Addendum No. 1
Flume 1 Reconstruction
Contract No. 0910-101
September 21, 2009

FLUME 1 RECONSTRUCTION
ADDENDUM #1

DETAIL $\frac{4}{F2}$

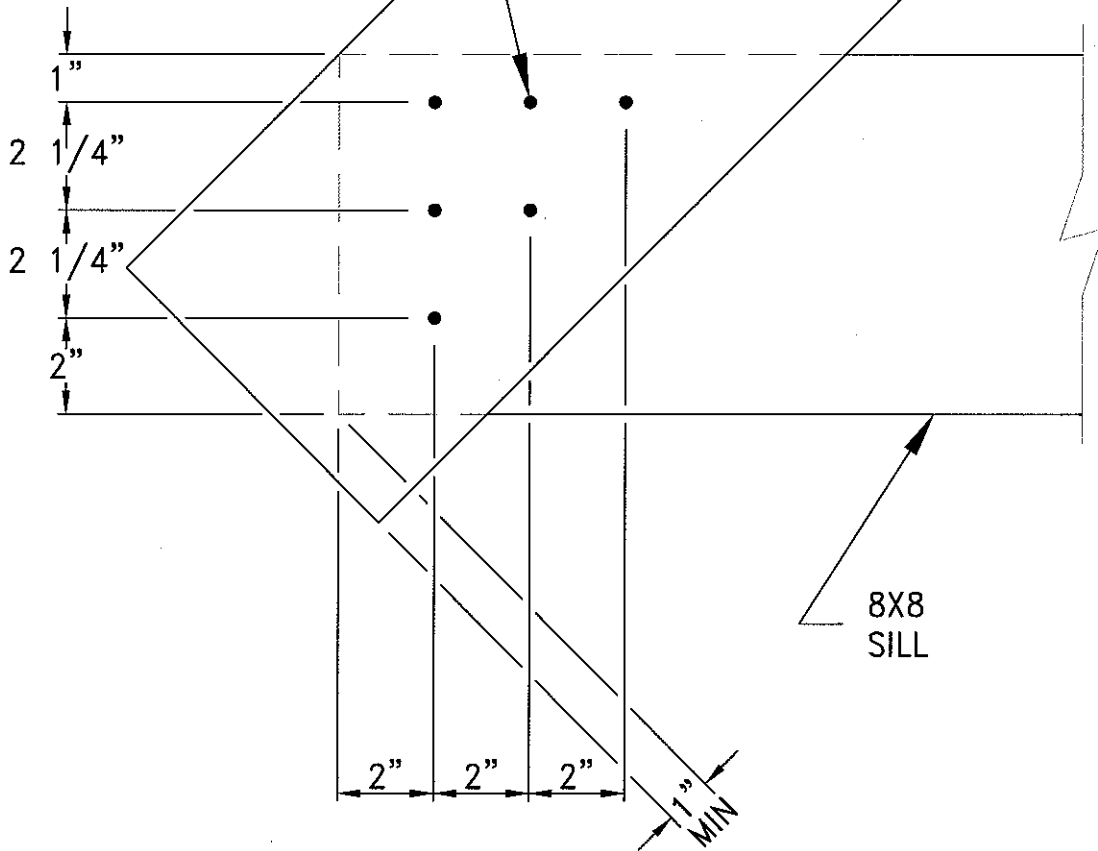
2. **Drawing Change.** MODIFY the nailing pattern description for Item 2 in Table 1 on Drawing F1 to read (changes in bold):
“6 – 30d (**0.192”** x **4¼”**) **sinker** nails each into sill and post.”

3. **Drawing Change.** ADD Detail 4/F2 to Drawing F2 as shown on attached Figure A1.
4. **Specification Change.** ADD the following subparagraph to Article 6.03 of the Supplementary Conditions:
“B. Per the city engineering department plan review, the Contractor shall submit the SWPPP and the main truck routes for material hauling for city review. The building permit will not be issued until the city has reviewed and approved the documents.”

30d (0.192" x 4 1/4") SINKER
NAILS (6 TOTAL) SPACED
AS SHOWN.

1. PREDRILL HOLES IF REQ'D TO PREVENT SPLITTING.
2. CONNECTION AT SILL IS SHOWN; CONNECTION AT POST IS SIMILAR.
